Proposal for an update of subclause 6.8 Topology discovery

Recap of 60802-Dorr-LLDP-0322-v01.pdf Summary:

50 **Figure 1 – Usage example of LLDP**

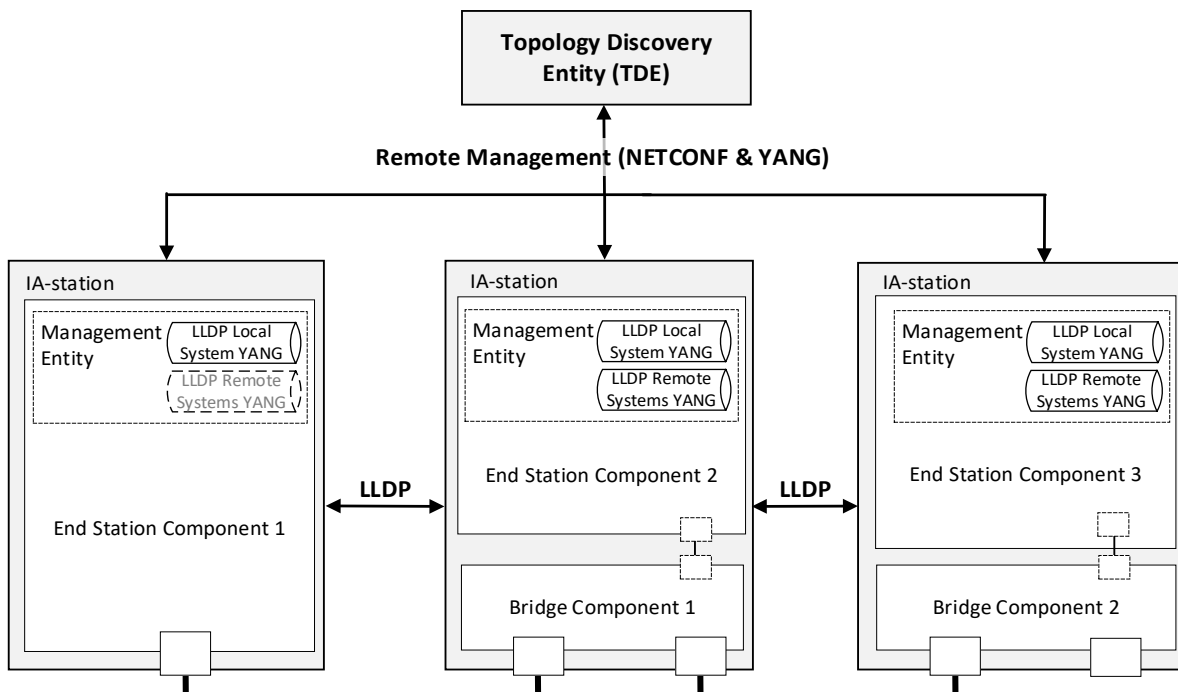
- Corrected Figure 1 – Usage example of LLDP: -> see Figure 1
 - All IA-stations include an end station component.
- Added subclause 6.8.2.3.4 Time To Live TLV: -> see 6.8.2.3.4
 - Describe all selected TLVs.
- Changed uniqueness of Chassis-ID and Port-ID -> see 6.8.2.3.2, 6.8.2.3.3

51 Figure 1 illustrates an exemplary network showing the LLDP agent implementations in an IA-
52 station consisting of a single end station component and two IA-stations with end station and

53 Bridge components (see 4.3). The LLDP protocol is used to convey neighborhood information
54 among peers, and NETCONF is used between the TDE and the IA-stations to query this
55 neighborhood information from the IA-stations. This information allows the TDE to discover IA-
56 stations and the physical network topology.
